8003-001-102-PVM-B-007

1X800 MW NTPC SIPAT STPP, STAGE-III

GENERAL ARRGT. OF BOILER-PLAN "A-A"

0-00-022-78129

SECTIONAL PLAN "A-A"
(AT EL 14700)

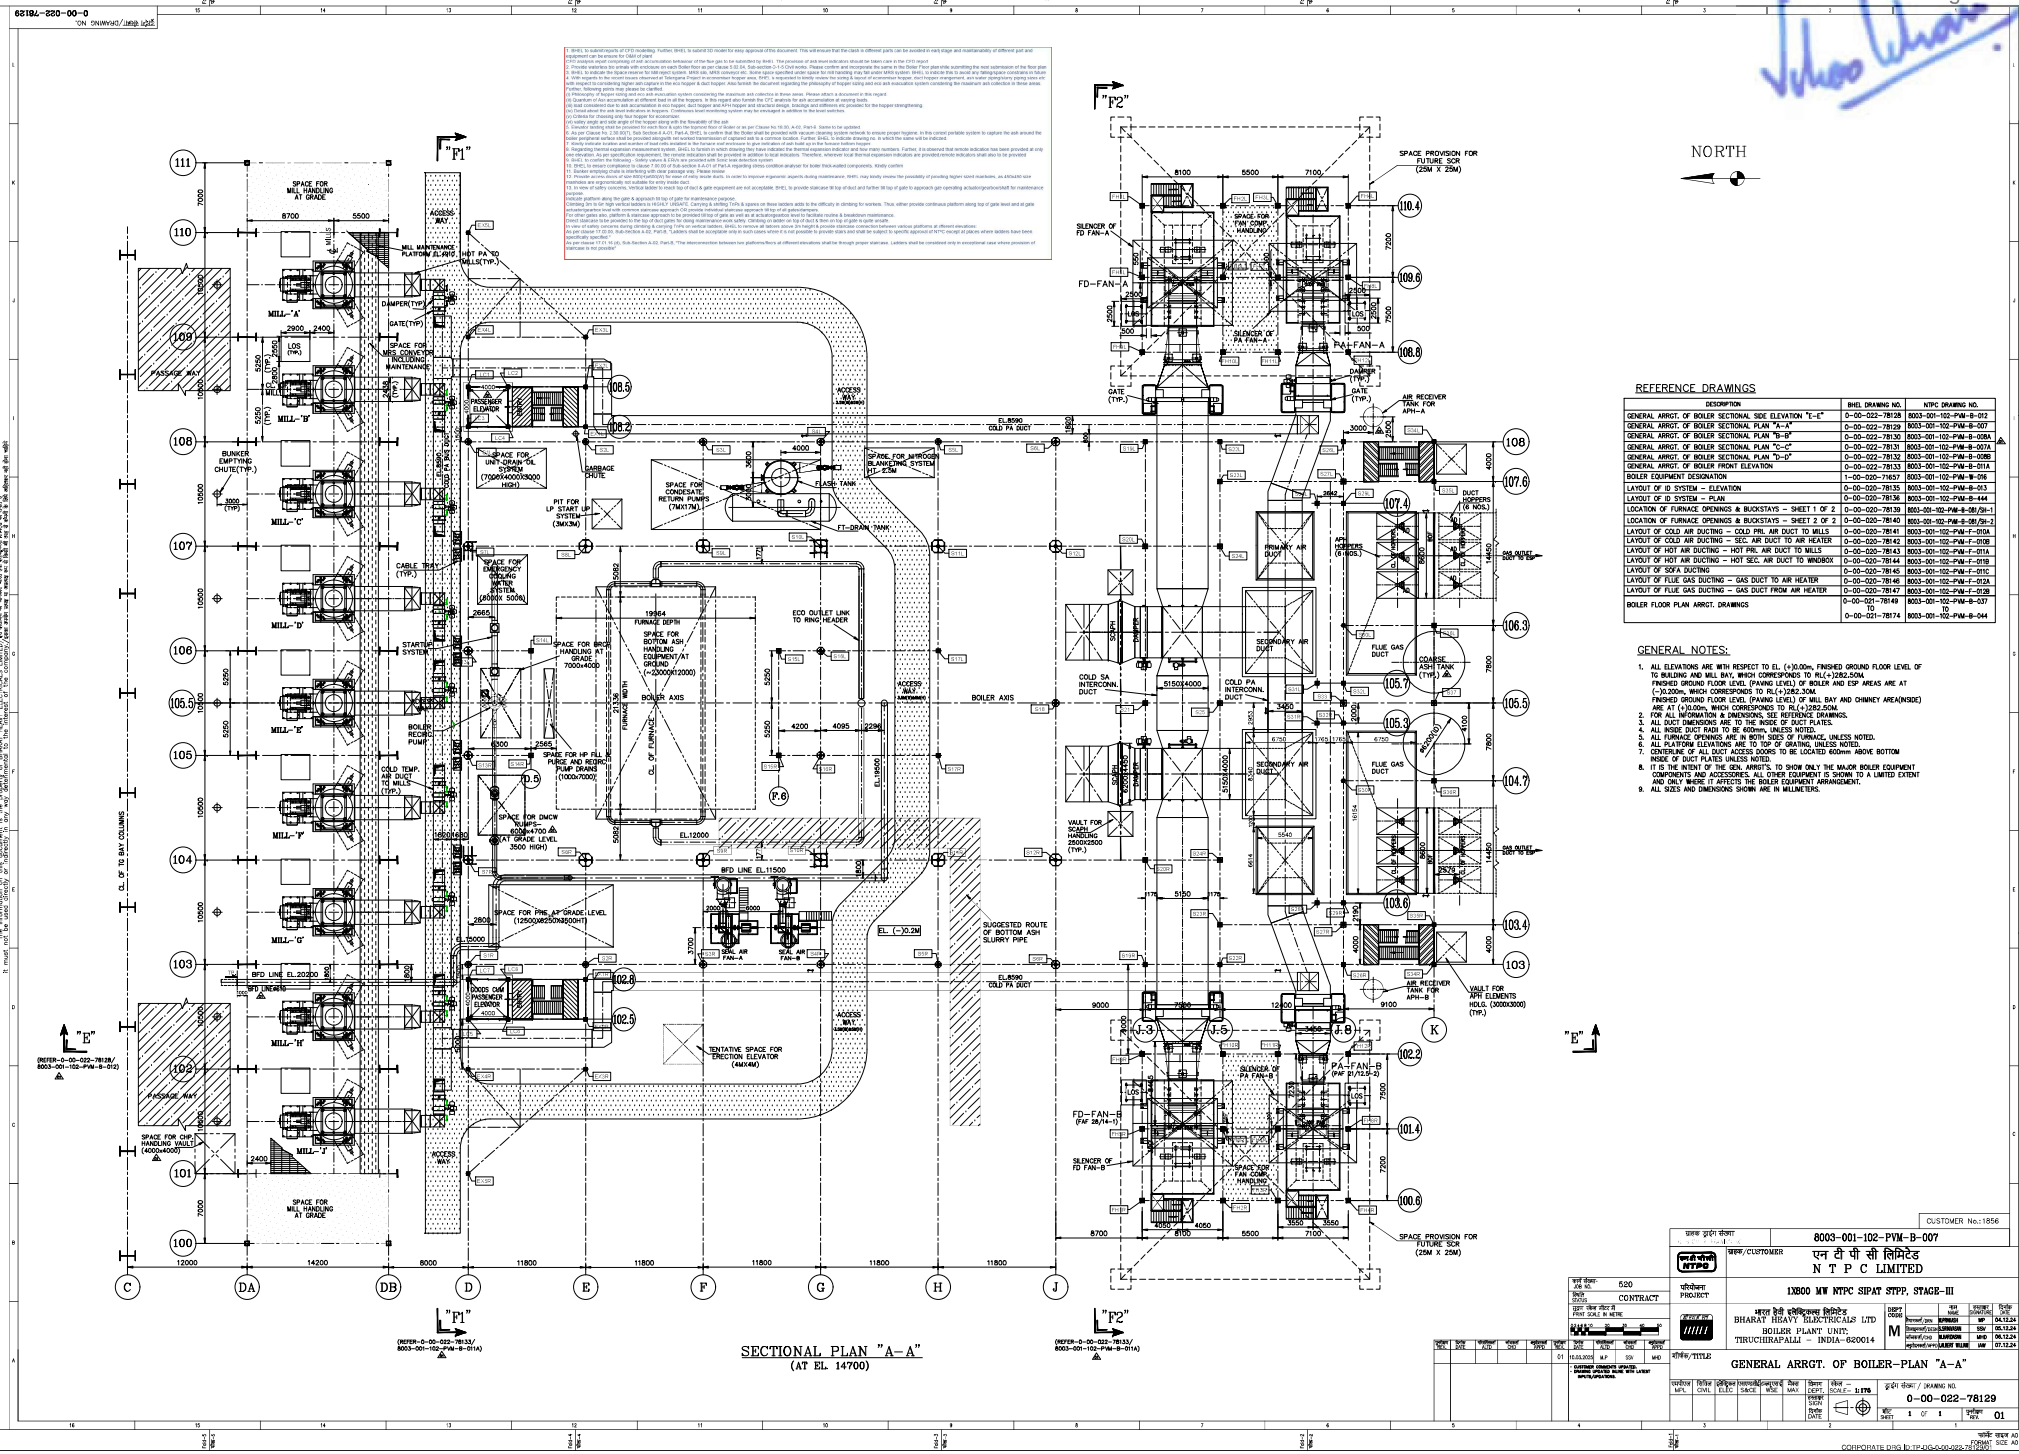
1. BHEL to submit reports of CFD modelling. Further, BHEL to submit 3D model for easy approval of this document. This will ensure that the clash in different parts can be avoided in early stage and maintainability of different part and equipment can be ensured by Clash of parts.

2. To analyse ash bypassing and ash accumulation behaviour of the flue gas to be submitted by BHEL. The provision of ash level indicators should be taken care in the CFD report

3. Provide waterlines for arrears with enclosure on each Boiler floor as per clause 5.32.8A, Sub-section C-1-5.0vol works. Please confirm and incorporate the same in the Boiler Floor plan while submitting the next submission of the floor plan

5. BHEL to indicate the Space reserve for bib reject system, MRSS silo, MRS conveyor etc. Some space specified under space for mill handling may fall under MRS system. BHEL to indicate this to avoid any fitting/space constrains in future

6. Provide adequate space between equipment and structure for easy maintenance. Not much space is left between Bottom ash hopper & bottom ash slurry pipe, Coal bunker hopper, duct hopper arrangement, ace water piping/pipes piping lines etc with respect to considering higher ash capture in the eco hopper & duct hopper. Also furnish the document regarding the philosophy of hopper sizing and anti ash accumulation system considering the maximum ash collection in these areas. Further, following points may please be clarified.

(i) Philosophy of hopper sizing and eco ash evacuation system considering the maximum ash collection in these areas. Please attach a document in this regard
(ii) Quantum of duct accumulation at different load in all the hoppers. In this regard also furnish the CFD analysis for ash accumulation at varying loads.
(iii) Provision of ash level indicators in hoppers. Provision of ash level indicators in hopper and structural design, leakage and stiffeners etc provided for the hopper strengthening.
(iv) Detail about the ash level indicators in hoppers. Continuous level monitoring system may be envisaged in addition to the level switches.

(v) Criteria for cleaning only four hopper for economizer.
vi) safety angle and side angle of the hopper along with the flowability of the ash
7. Elevator landing sheet be provided for each floor & upto the topmost floor or ladder or as per Clause No.16.30, A-01, Part-II. Same to be updated.

8. Provide Ladder at EL 20200 & EL 11500 of BFD line. Provide ladder at EL 20200 of BFD line and provide platform at EL 11500 of BFD line to ensure proper hygiene. In this context portable system to capture the ash around the boiler peripheral surface shall be provided alongside on evacuated transmission of conjoined ash to a common location. Further, BHEL to indicate drawing no. in which the same will be indicated.

7. Ideally indicate location and number of load cells installed in the furnace roof enclosure to give indication of ash build up in the furnace bottom hopper

9. Regarding thermal expansion measurement system, BHEL to furnish in which drawing they have indicated the thermal expansion indicator and how many numbers. Further, it is observed that remote indication has been provided at only one elevation. As per specification requirement, the remote indication shall be provided in addition to local indications. Therefore, wherever local thermal expansion indications are provided remote indication shall also to be provided at all locations. Please confirm and incorporate the same in the Boiler Floor plan.

10. BHEL to ensure compliance to clause 7.30.03 of Sub-section A-A-01 of Part-A regarding stress condition analysis for boiler thick-walled components. Kindly confirm

11. Bunker emptying chute is interfering with clear passage way. Please review
12. Provide access doors of size 600X1800mm for ease of entry inside ducts. In order to improve ergonomic aspects during maintenance, BHEL may kindly review the possibility of providing higher sized manholes, as 450x600 size manholes are ergonomically not suitable for entry inside duct.

13. In view of safety concerns, Vertical ladder to reach top of duct & gate equipment are not acceptable. BHEL to provide staircase till top of duct and further till top of gate to approach gate operating actuator/gearbox/shaft for maintenance purpose.
Include platform along the gate & approach till top of gate for maintenance purpose.
Vertical ladder to reach top of duct & gate is not acceptable. BHEL to provide staircase till top of duct & gate to approach gate operating actuator/gearbox/shaft for maintenance purpose.
Unclimbable gratings must be provided on the top of duct & gate to prevent accidents. Provide adequate space on these ladders aside to the difficulty in climbing for workers. Thus, either provide continuous platform along top of gate level and at gate operating actuator level with transverse staircase approach OR provide individual staircase approach till top of all gates/dampers.

For other gates also, platform & staircase approach to be provided till top of gate as well as at actuator/gearbox level to facilitate routine & breakdown maintenance.
Direct clearance to be provided to the top of duct/ gates for doing maintenance work safely. Climbing on ladder on top of duct & then on top of gate is quite unsafe
In view of safety concerns during climbing & carrying TWPs on vertical ladders, BHEL to remove all ladders above 2m height & provide staircase connection between various platforms at different elevations
Clause 17.21.16 (d), Sub-Section A-02, Part-B, "Ladders shall be acceptable only in such cases where it is not possible to provide stairs and shall be subject to specific approval of NTPC except at places where ladders have been specifically specified."
As per clause 17.21.16 (d), Sub-Section A-02, Part-B, "The interconnection between two platforms/floors at different elevations shall be through proper staircase. Ladders shall be considered only in exceptional case where provision of staircase is not possible"
